ORE - TRAFFIC: January 2026 Proposed SDMM Updates Summary

STANDARD SIGN DESIGN

ODOT - OFFICE OF TRAFFIC OPERATIONS

CODE NO.: D4-H2a

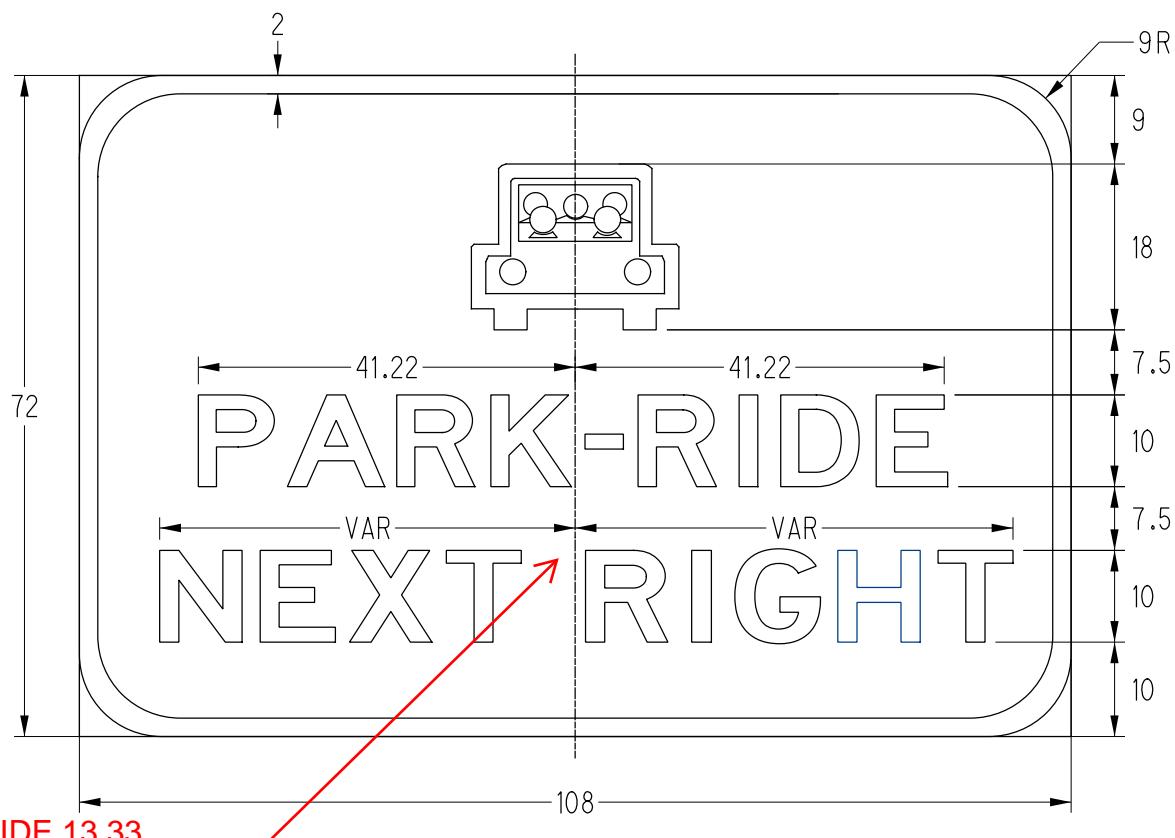
| Revision Type | Reference | Section Description (Red indicates Change of name from existing) | Description of Revision | New or Deletion | Primary POC |
|---------------|-----------|-------------------------------------------------------------------------------------------|---------------------------------------------------------------------------------------------------------------------------------------------------------------------|-----------------|-------------|
| SDMM | D4-H2a | (carpool symbol) / PARK-RIDE / NEXT RIGHT | Change text size to 12 | | Eberhardt |

CODE NO.: D4-H2b

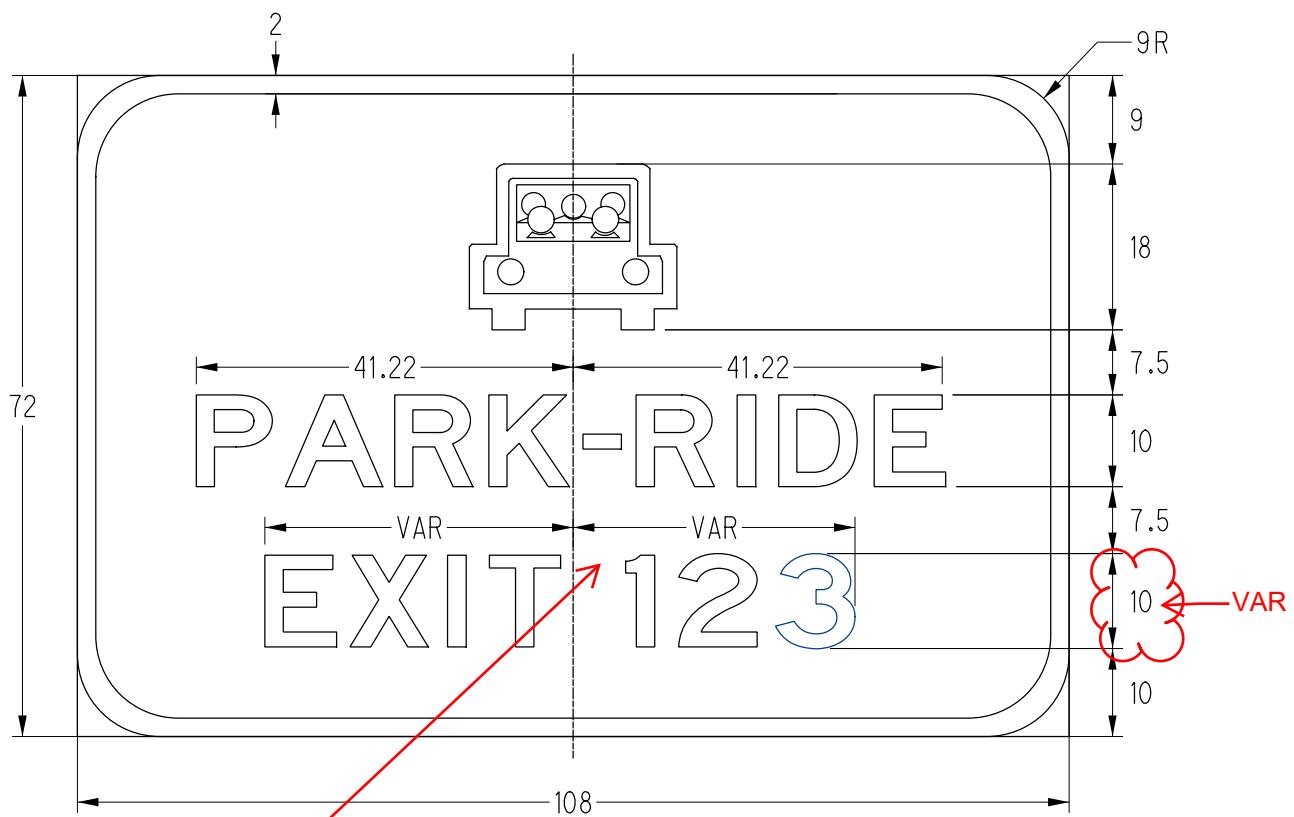
| Revision Type | Reference | Section Description (Red indicates Change of name from existing) | Description of Revision | New or Deletion | Primary POC |
|---------------|-----------|-------------------------------------------------------------------------------------------|---------------------------------------------------------------------------------------------------------------------------------------------------------------------|-----------------|-------------|
| SDMM | D4-H2b | (carpool symbol) / PARK-RIDE / EXIT XX | Change text size to 12 | | Eberhardt |

CODE NO.: D10-4

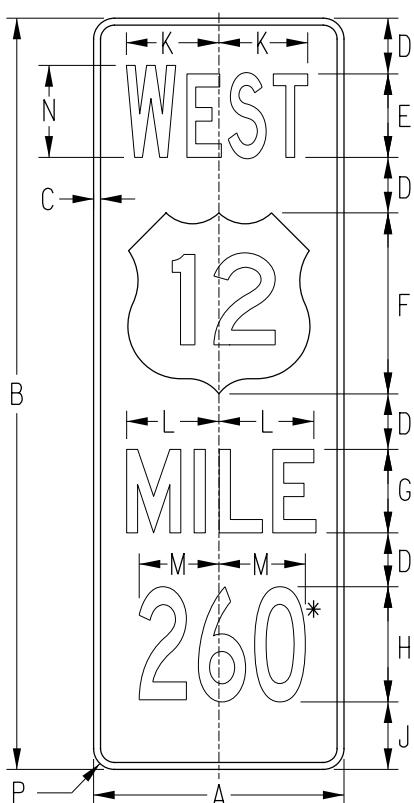
| Revision Type | Reference | Section Description (Red indicates Change of name from existing) | Description of Revision | New or Deletion | Primary POC |
|---------------|-----------|-------------------------------------------------------------------------------------------|---------------------------------------------------------------------------------------------------------------------------------------------------------------------|-----------------|-------------|
| SDMM | D10-4 | Enhance Reference Location Sign | Change background color to green | | Soisson |

Change background to green

WHITE ON ~~BLUE~~
Green

Engineering reason for change: The 11th Edition of the MUTCD removed the option for a blue background on the Enhanced Reference Location Sign. Changing the color to green brings this sign more in line with the other location signs

CODE NO.: D10-5

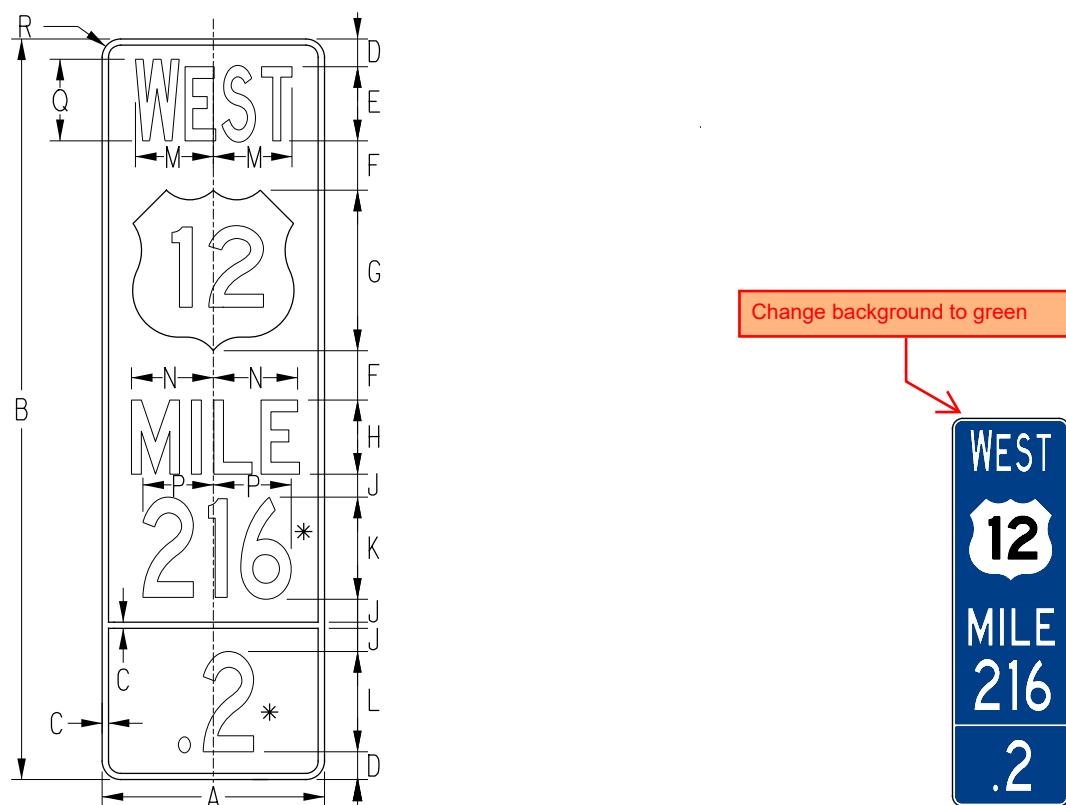
| Revision Type | Reference | Section Description (Red indicates Change of name from existing) | Description of Revision | New or Deletion | Primary POC |
|---------------|-----------|-------------------------------------------------------------------------------------------|---------------------------------------------------------------------------------------------------------------------------------------------------------------------|-----------------|-------------|
| SDMM | D10-5 | Intermediate Enhance Reference Location Sign | Change background color to green | | Soisson |

WHITE ON BLUE
Green

Engineering reason for change: The 11th Edition of the MUTCD removed the option for a blue background on the Enhanced Reference Location Sign. Changing the color to green brings this sign more in line with the other location signs

CODE NO.: D10-H5a

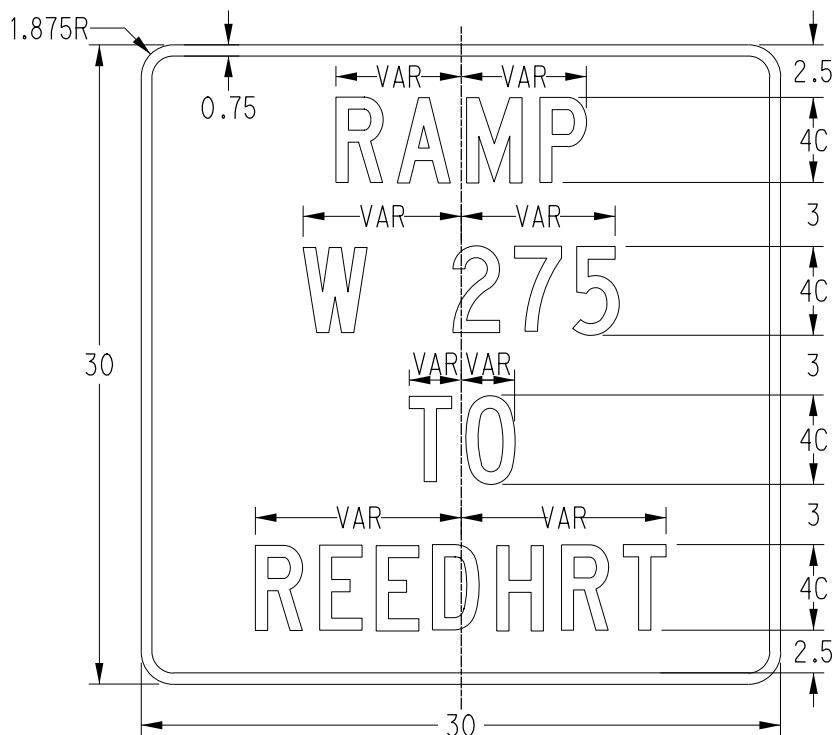
| Revision Type | Reference | Section Description (Red indicates Change of name from existing) | Description of Revision | New or Deletion | Primary POC |
|---------------|-----------|-------------------------------------------------------------------------------------------|---------------------------------------------------------------------------------------------------------------------------------------------------------------------|-----------------|-------------|
| SDMM | D10-H5a | Ramp Identification/ Reference Sign | Change background color to green | | Soisson |

Updated sheet showing
white on green

CODE NO.: E9-H1a

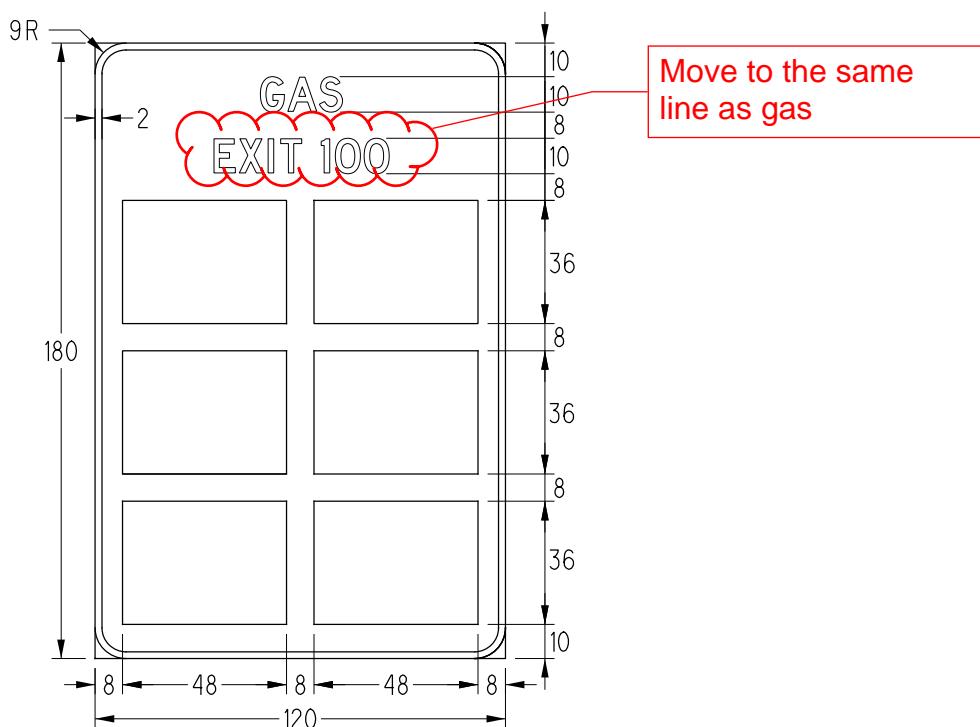
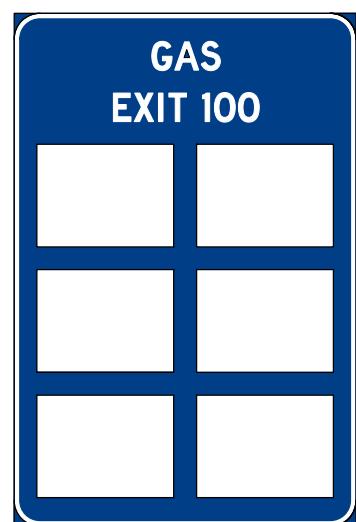
| Revision Type | Reference | Section Description (Red indicates Change of name from existing) | Description of Revision | New or Deletion | Primary POC |
|---------------|-----------|-------------------------------------------------------------------------------------------|---------------------------------------------------------------------------------------------------------------------------------------------------------------------|-----------------|-------------|
| SDMM | E9 Series | Narrow Logo Signs | Move the exit number text inline with the destination subject (gas/food, etc), along with dimension changes. Applies to E9-H1a, E9-H2a, E9-H2b, E9-H3a, and E9-H4a. | | Eberhardt |

CODE NO.: I-H15

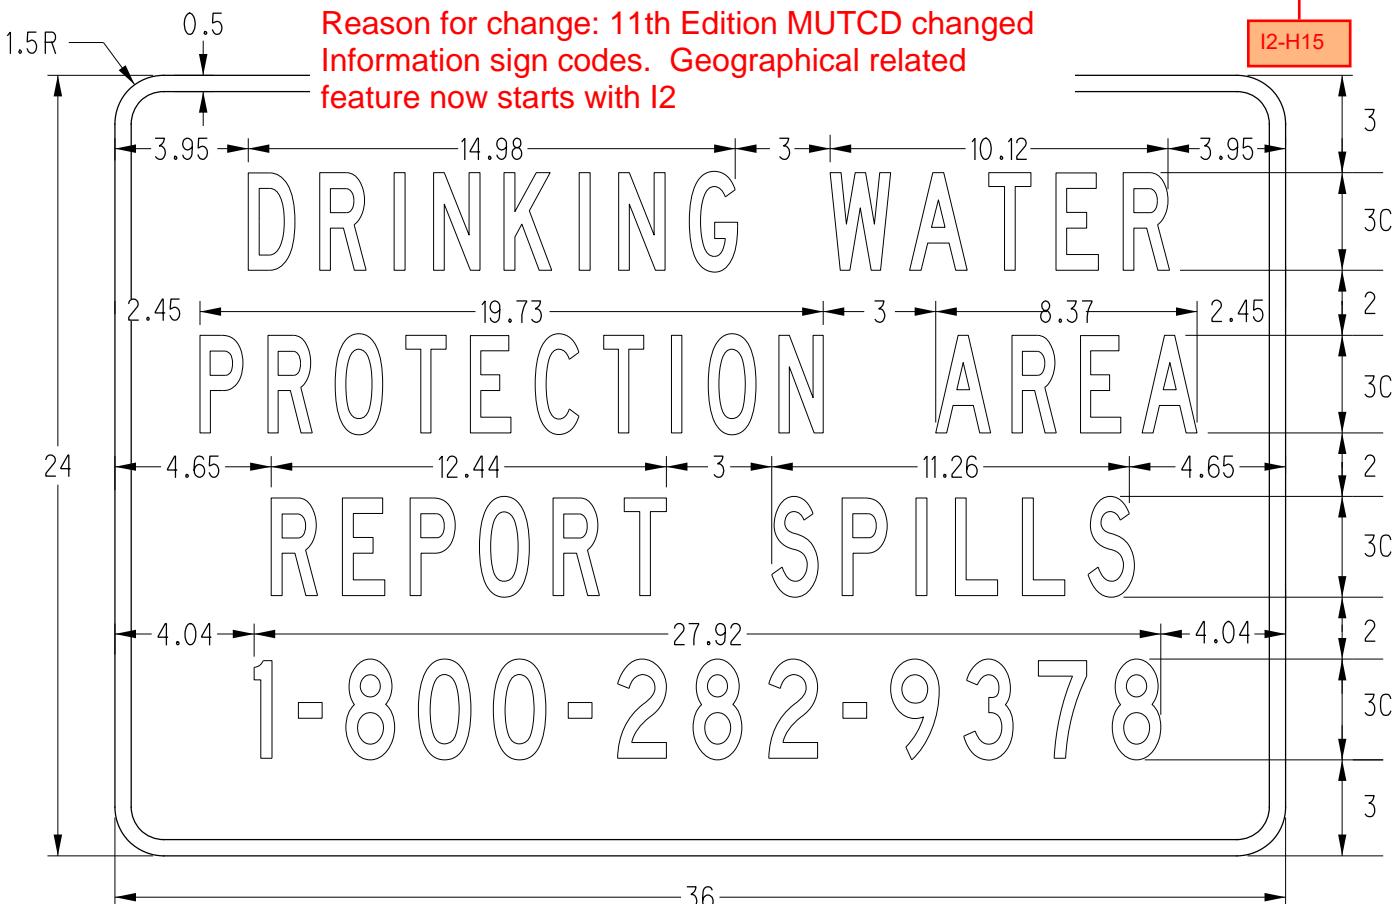
| Revision Type | Reference | Section Description (Red indicates Change of name from existing) | Description of Revision | New or Deletion | Primary POC |
|---------------|-----------|-------------------------------------------------------------------------------------------|---------------------------------------------------------------------------------------------------------------------------------------------------------------------|-----------------|-------------|
| SDMM | I-H15 | Drinking Water Protection Area | Being retired. Change sign code to I2-H15 | Deletion | Soisson |
| SDMM | I2-H15 | Drinking Water Protection Area | Previously was Signcode I-H15. Change background color to green | New | Soisson |

I2-H15

Change background to green

Reason for change: General information signs related to geographical features have a green background

CODE NO.: I20-H6a

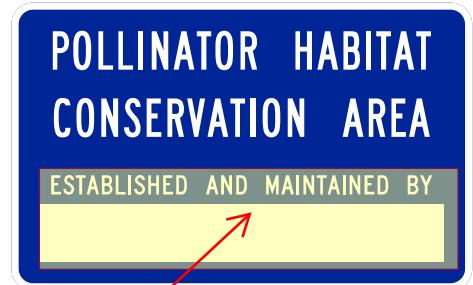
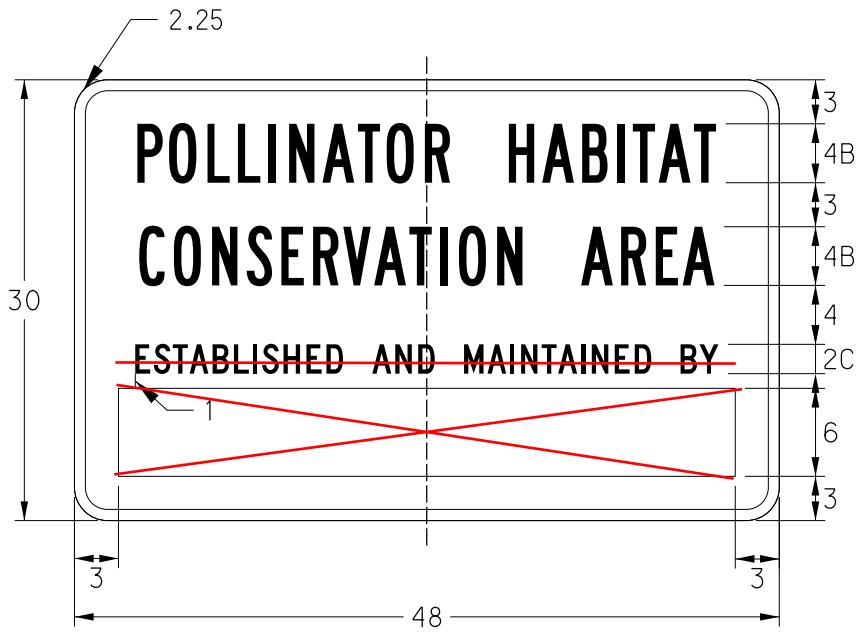
| Revision Type | Reference | Section Description (Red indicates Change of name from existing) | Description of Revision | New or Deletion | Primary POC |
|---------------|-----------|-------------------------------------------------------------------------------------------|---------------------------------------------------------------------------------------------------------------------------------------------------------------------|-----------------|-------------|
| SDMM | I20-H6a | POLLINATOR HABITAT CONSERVATION AREA - DO NOT MOW <i>Established and Maintained by</i> | <ul style="list-style-type: none"> Delete "Established and Maintained by" and logo Replace logo with "DO NOT MOW" Resize sign | | Soisson |

delete per Joel Hunt
email on 5/14/25

CODE NO.: M8-H4a

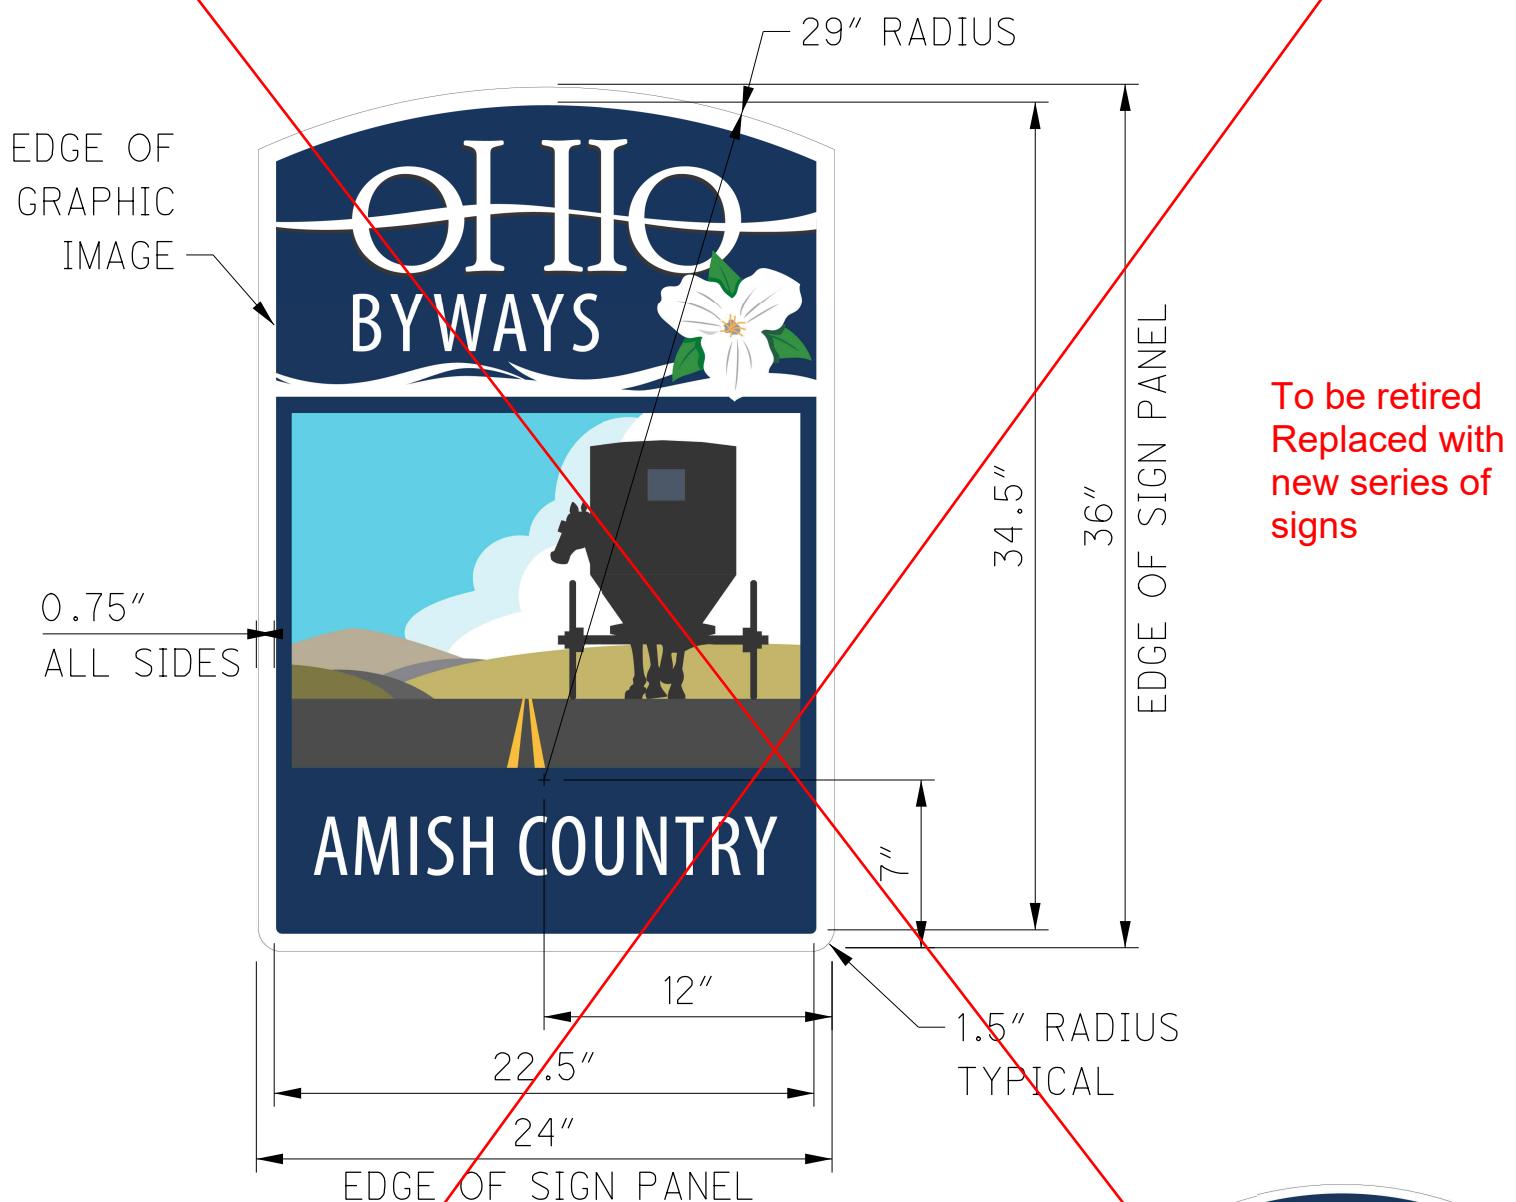
| Revision Type | Reference | Section Description (Red indicates Change of name from existing) | Description of Revision | New or Deletion | Primary POC |
|---------------|-----------|-------------------------------------------------------------------------------------------|---------------------------------------------------------------------------------------------------------------------------------------------------------------------|-----------------|-------------|
| SDMM | M8-H4a | Ohio Byway - Amish Country Scenic Byway | Retiring existing sign. Being replaced by M10-H3aa | Deletion | Soisson |

To be retired
Replaced with
new series of
signs

CODE NO.: M8-H4e

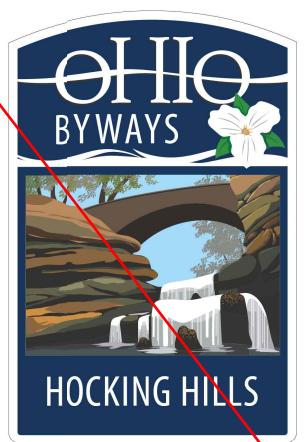
| Revision Type | Reference | Section Description (Red indicates Change of name from existing) | Description of Revision | New or Deletion | Primary POC |
|---------------|-----------|-------------------------------------------------------------------------------------------|---------------------------------------------------------------------------------------------------------------------------------------------------------------------|-----------------|-------------|
| SDMM | M8-H4e | Ohio Byway - Hocking Hills Scenic Byway | Retiring existing sign. Being replaced by M10-H3ae | Deletion | Soisson |
